# ALTERATION TO A HISTORIC PROPERTY STAFF REPORT

Site / District(s): 30 Bow Street / LHD

Case: HPC 2014.005

Legal Notice: Construct brick veneer replica chimney.

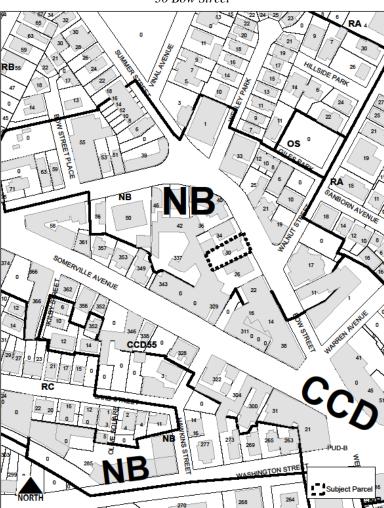
The original chimney has already been removed. The Applicant has replicated the chimney in size, shape and color of brick, and added a chimney cap that does not obstruct the chimney.

Staff determines that the alteration for which an application for a Historic Certificate has been filed is appropriate for and compatible with the preservation and protection of the Bow Street Local Historic District; therefore Staff recommends the Historic Preservation Commission to grant Mark Boyes-Watson a Certificate of Appropriateness to construct a brick veneer chimney and add a chimney cap at 30 Bow Street that is consistent in size, shape, and brick color to the original.
